# **Proposed Plan Change 14:**

**Mangaone Precinct & C10 Industrial  
Growth Cell - Hautapu**

**Reporting Officer Right of Reply of  
Hayley Marie Thomas**

**On behalf of Waipā District Council**

**Figure 1:** Existing Bardowie Industrial Precinct Structure Plan with connection to the Henmar Trust land circled in red

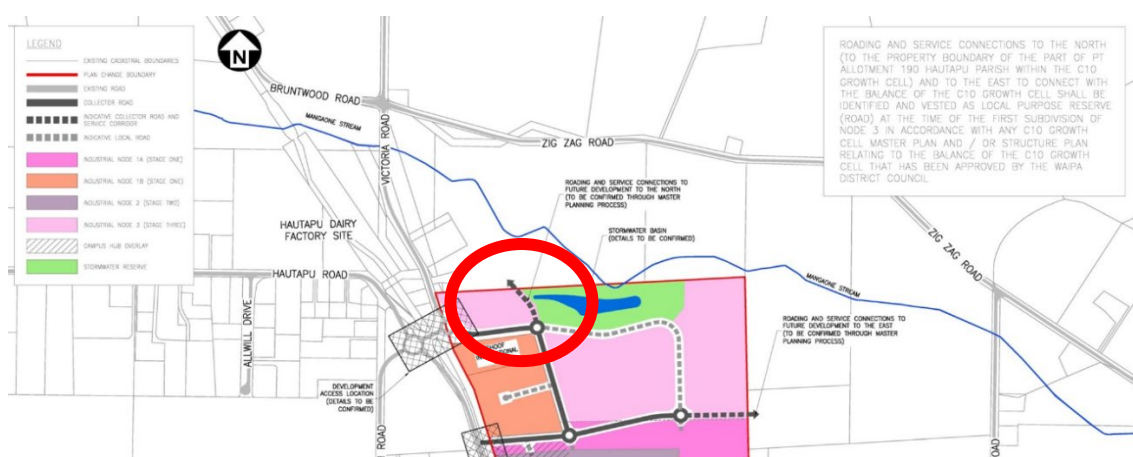
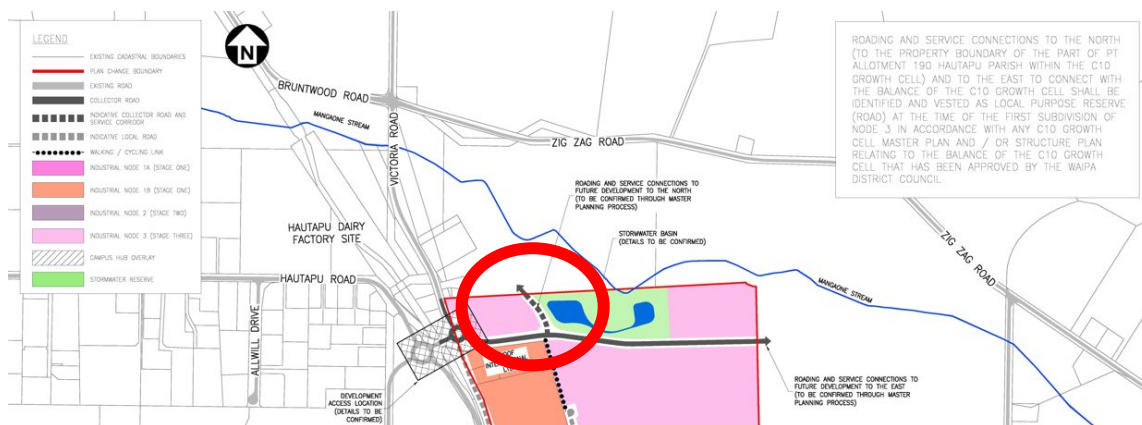
4.31 In his legal submission, Mr Phil Lang, outlined his opinion that the proposed roading arrangements in PC14 are contrary to agreements made with Council under Plan Change 11. Council staff have considered this matter and note the existing Bardowie Industrial Precinct has an ‘Indicative Collector Road’ line and link from Bardowie Industrial Precinct to the Henmar Trust land directly to the north. Refer Figure 1 below. Figure 2 below (as shown in Appendix 2 of the Section 42A Report) shows the proposed amended Bardowie Industrial Precinct Structure Plan lodged with PC14. Of note is that the connection to the Henmar Trust land has been retained and is unaltered contrary to Mr Lang’s evidence.

4.32 In terms of the form of this connection at the time it is required, this is noted on the Structure Plan as ‘to be confirmed through Master Plan Process’. This text is not being changed as part of PC14. Council staff remain of the opinion that this will be worked through with the relevant landowners at the time it is proposed to be constructed. The commitments made under Plan Change 11 have not changed in this regard.

Figure 3: Preliminary Master Plan Layout – C10 Growth Cell

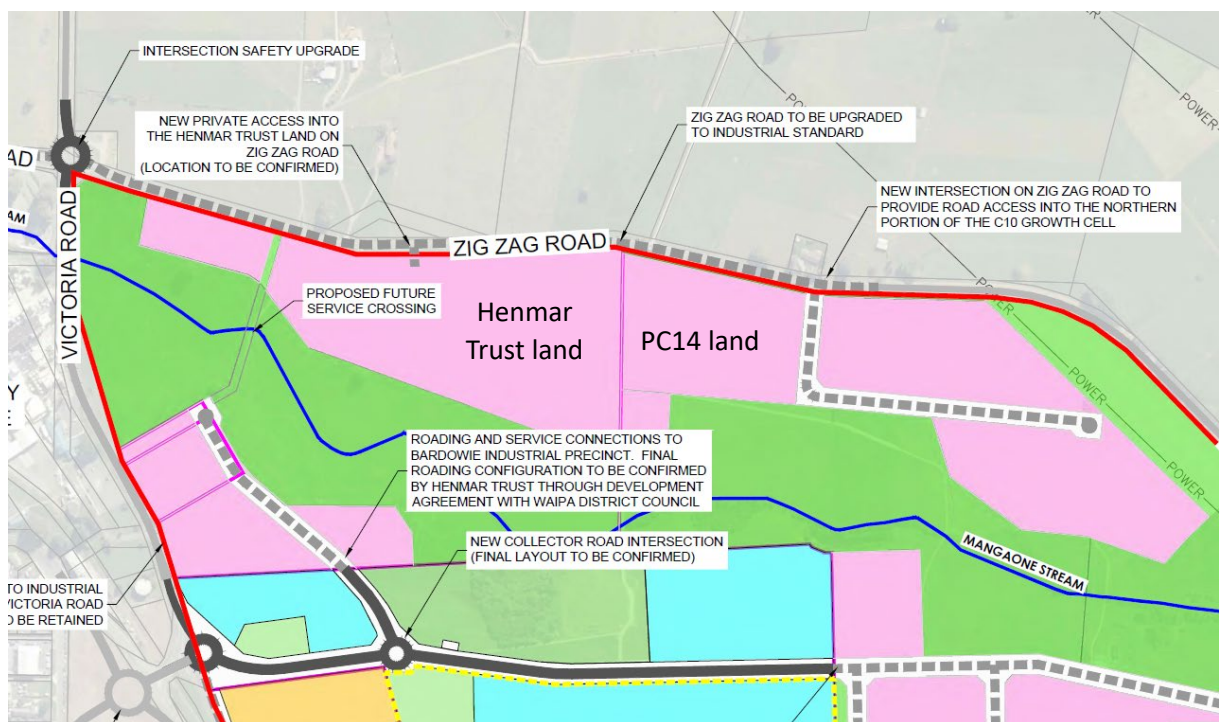
4.36 The Preliminary Master Plan Layout Plan for the C10 Growth Cell does not show a roading connection between the Henmar Trust land and the Fonterra land (refer Figure 3 below). The proposed Mangaone Precinct Structure Plan included with PC14 is consistent with the roading arrangement as shown on the Master Plan, with the exception that a new link across the Mangaone Stream is proposed.

4.37 I am of the opinion that connectivity between the Henmar Trust land and the PC14 land is appropriately provided by Zig Zag Road. Because of the small distances involved the provision of an internal roading connection is not necessary from a transport planning or network efficiency viewpoint. Council staff are also mindful that connectivity will be provided via the Mangaone Reserve (i.e. pedestrian/cycleway). As such there is no need for an additional roading connection as requested by Henmar Trust.

**Figure 4:** Henmar Trust land north of Zig Zag Road shown in yellow with PC14 land shown in red

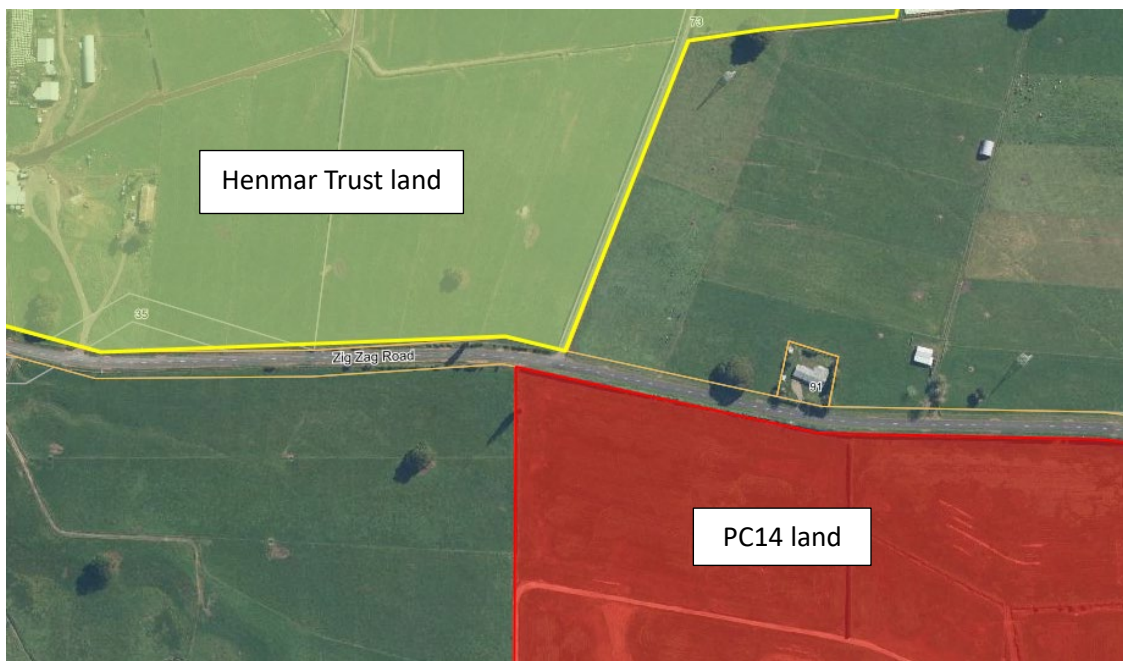
4.39 No expert landscape evidence has been provided to support these concerns. Figure 4 below highlights the land referred to by Mr Lang in yellow which is within the Rural Zone. The PC14 land closest to this boundary will be subject to the performance standards within the Industrial Zone including the following proposed provisions:

- (a) Rule 7.4.2.1(e) – Minimum building setback from road boundaries – 15m;
- (b) Rule 7.4.2.7A – Daylight Control – recession plane of 30 degrees from 3m above ground level at the road boundary;
- (c) Rule 7.4.2.15A – Landscaping and screening – 5m landscape buffer strip including post and rail fencing, 2m hedge, and trees spaced 10m apart;
- (d) Rule 7.4.2.17A – Building Colour – From groups of the British Standard 5252 colour chart listed in the provision; and
- (e) Rule 7.4.2.41 – Light Spill – all external lighting shall be shaded or directed away from residential dwellings and roads.

**Figure 5:** Henmar Trust land within C10 Growth Cell shown in yellow with PC14 land shown in red

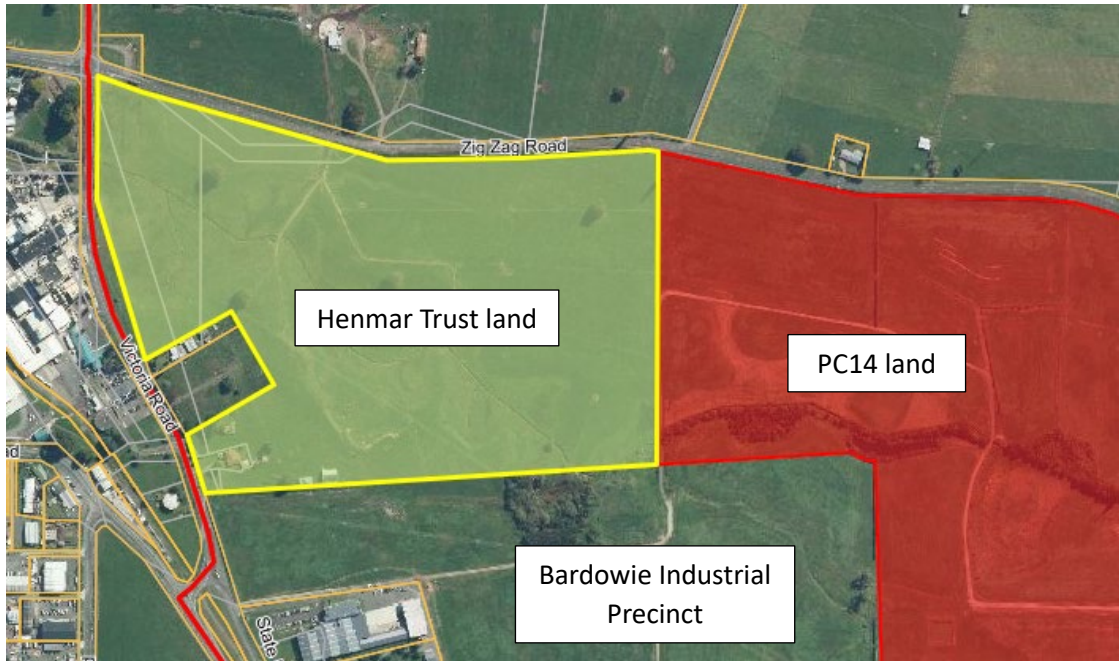
- 4.42 Mr Lang has outlined the Henmar Trust land within the C10 Growth Cell, and south of Zig Zag Road, will continue to be used for farming activities for an unknown period. This land is shown in Figure 5 below.
- 4.43 Noting the absence of any road or physical separation between the Industrial and Rural Zones, Mr Lang has suggested a '*substantial landscaping strip capable of screening a 20 metre buildings should be combined with a setback that will make the screening effective*'.<sup>2</sup>

4.44 In comparison to this I note that the southern boundary of the Henmar Trust land bordering the Bardowie Industrial Precinct is currently subject to the following development controls:

Figure 6: Preliminary Stormwater Strategy – C10 Growth Cell

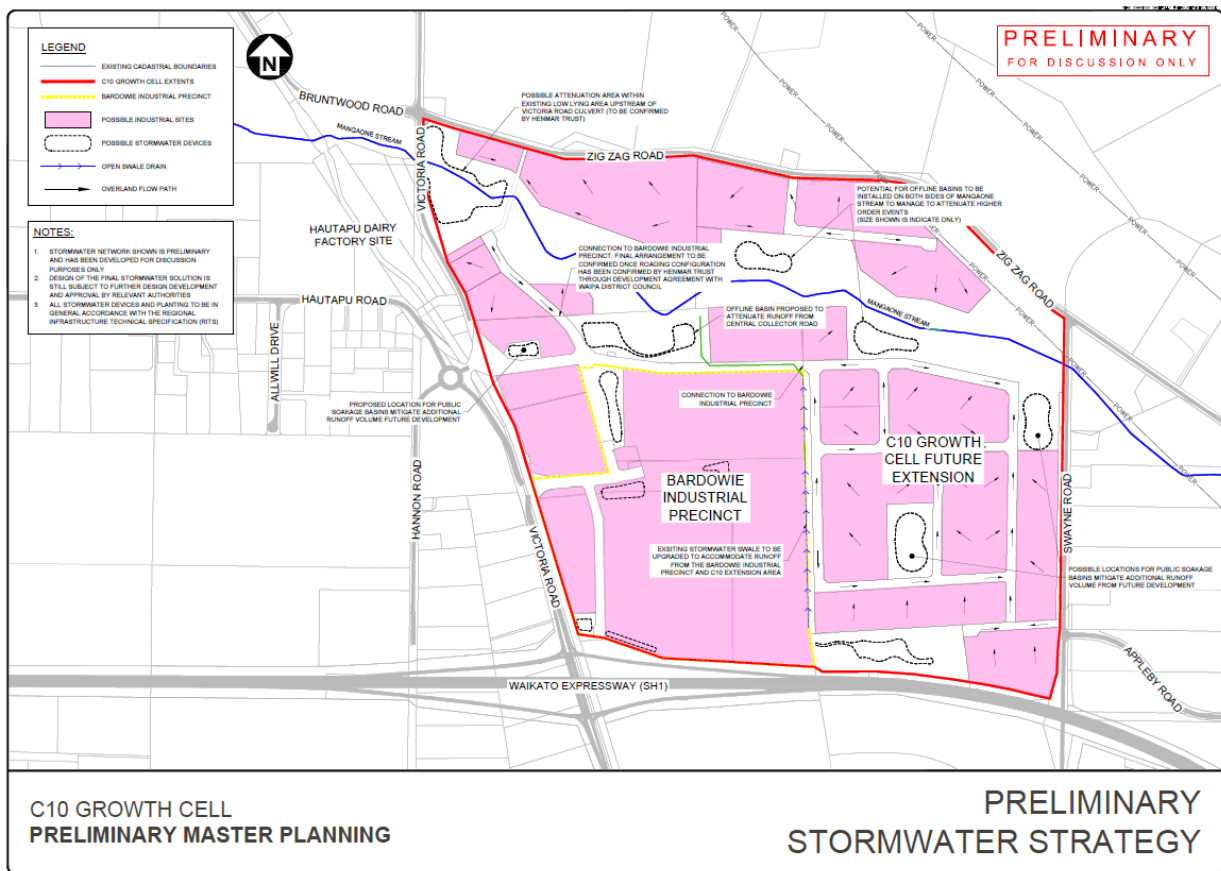
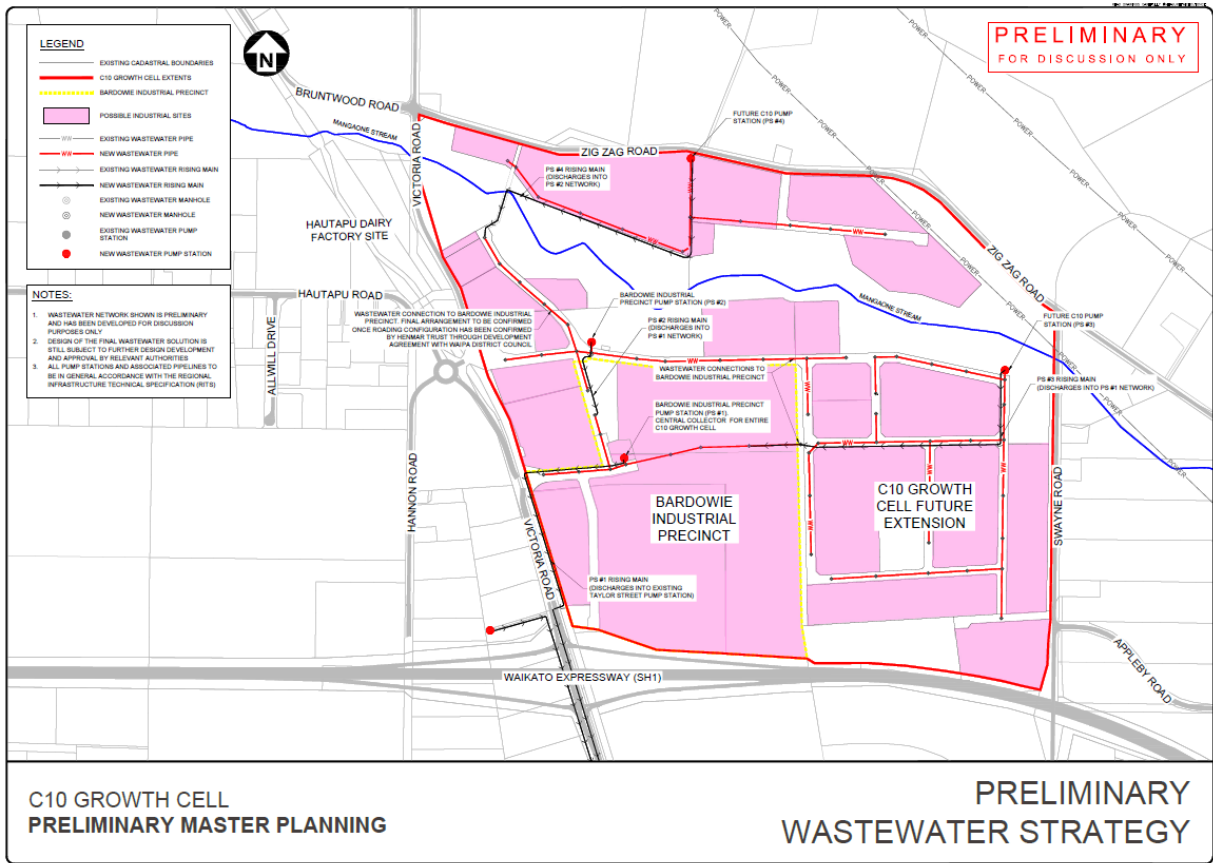
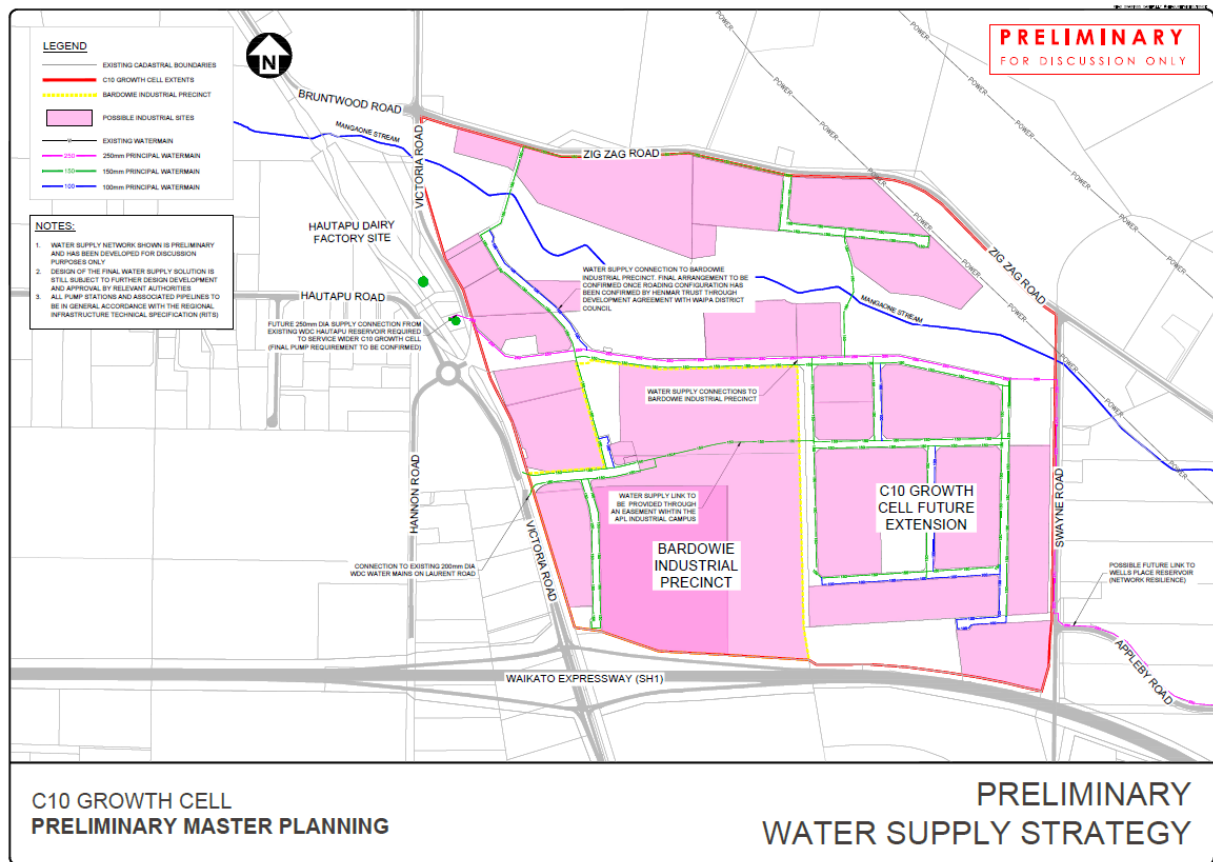
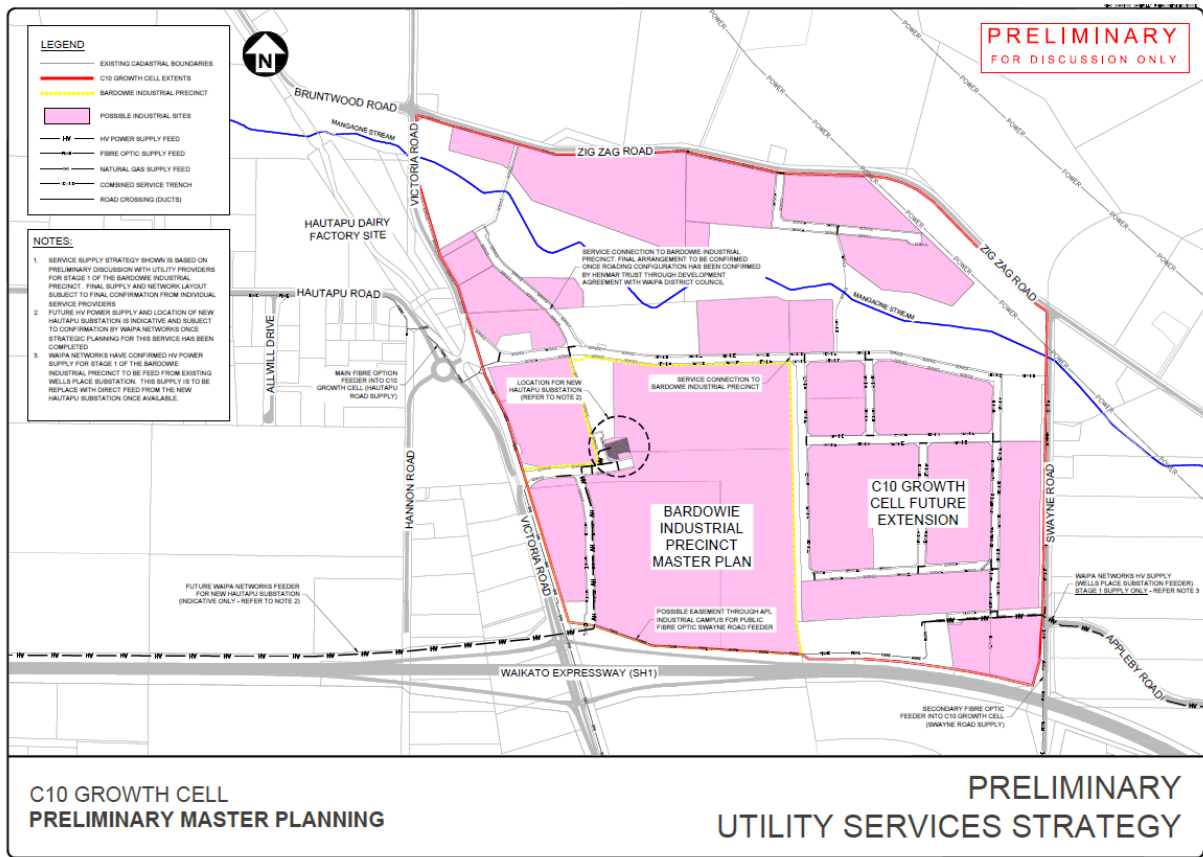
- 4.63 In terms of servicing, the current C10 Growth Cell Master Plan includes a wastewater, stormwater, water supply and utility services plan. These plans were included in the electronic version of Appendix B to Ms Bourke’s evidence and are shown below in

Figures 6 to 9. All of the plans have connections from the wider C10 Growth Cell to the Henmar Trust land to ensure all these services are provided for any future development.

**Figure 10:** Hautapu Industrial Zone including Area 6 and 7, and the Bardowie Industrial Precinct Area

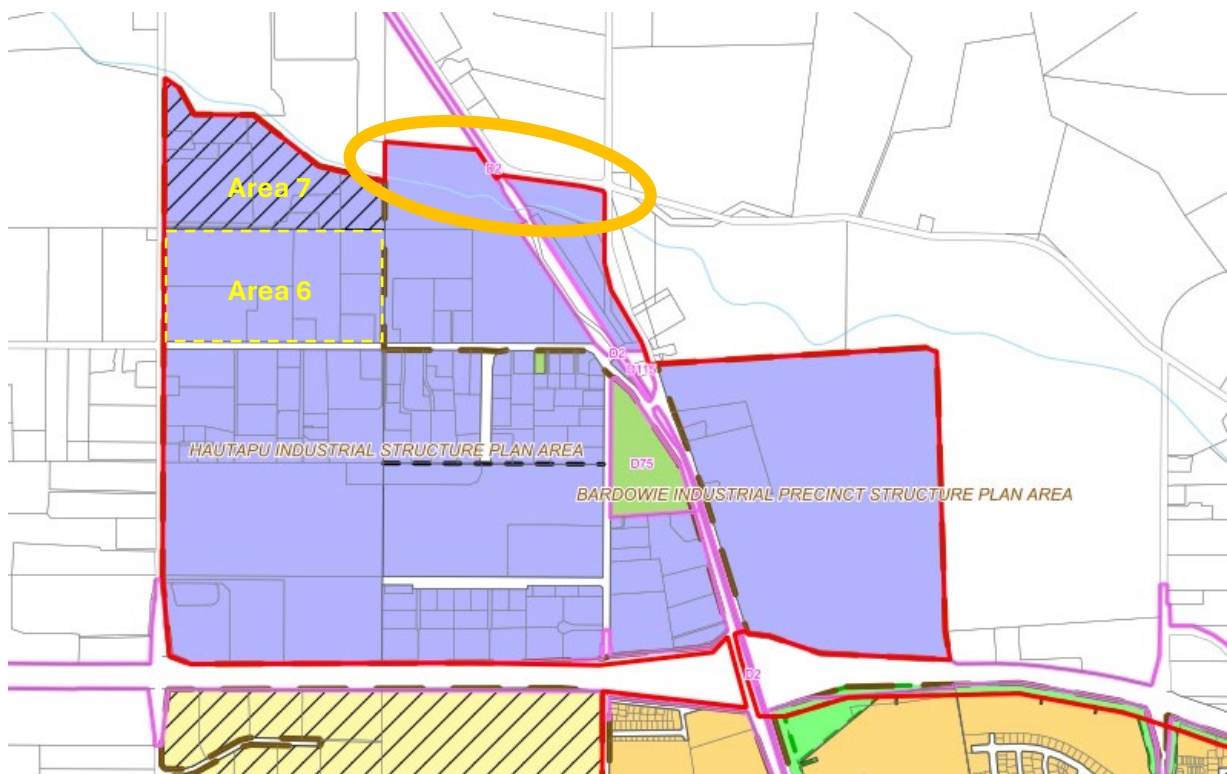
precincts in the District, particularly the Hautapu Industrial Precinct. Figure 10 below shows the entirety of the Hautapu Industrial Zone. Perimeter sites within Hautapu Industrial Zone are subject to perimeter landscaping as per Attachment A in Appendix S5 of the District Plan. The Hautapu Industrial Zone is bounded by the Waikato Expressway to the south and Peake Road on the western boundary. Both of these boundaries are therefore subject to provisions regarding road boundaries.

4.68 The northern boundary of the Hautapu Industrial Zone has split zoning in that a portion is 'live', and the western portion is deferred. The deferred zoning is known as 'Area 7' with 'Area 6' located directly south which was part of Plan Change 17. Refer Figure 10 below.

**Figure 11:** Proposed Bardowie Industrial Precinct Structure Plan snippet of intersection and legend

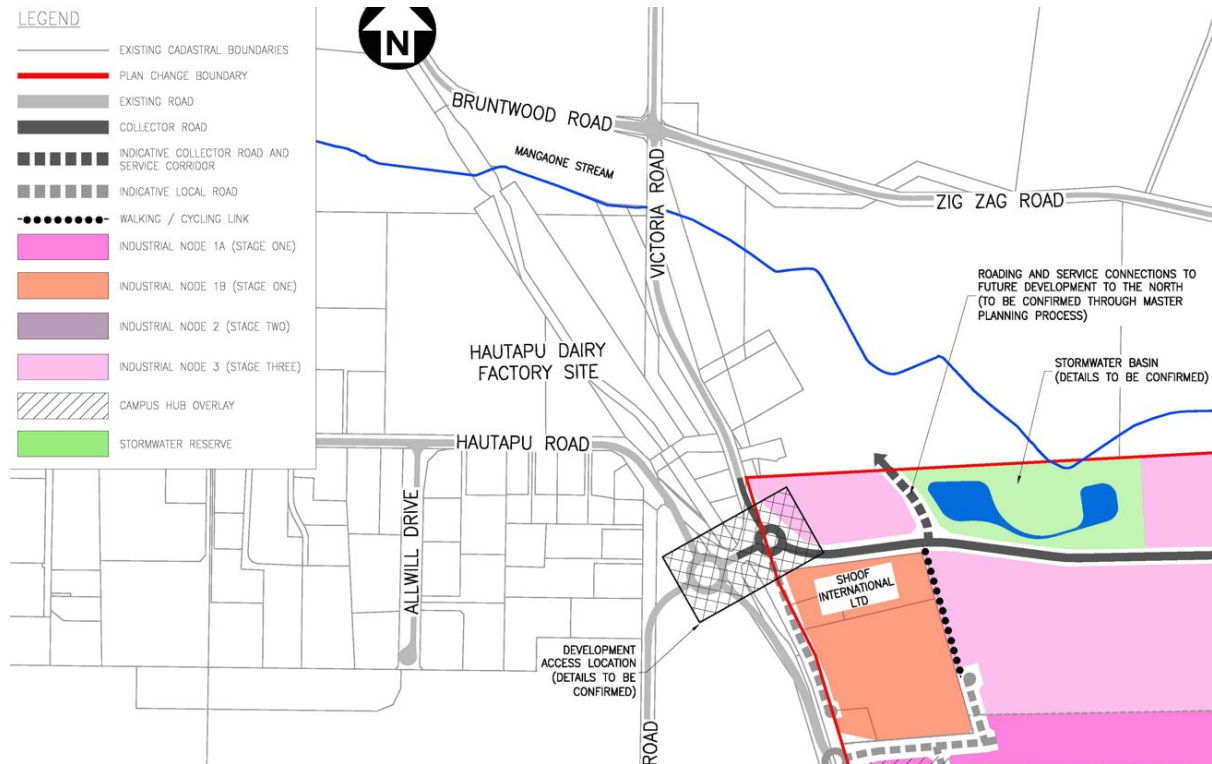
7.3 In paragraph 1.5, Ms Bourke states that a “four-lane intersection” is shown on the amended Bardowie Industrial Precinct Structure Plan. This is not the case, and the southern linkage shown at this intersection is a walking/cycling link only as shown below in Figure 11.
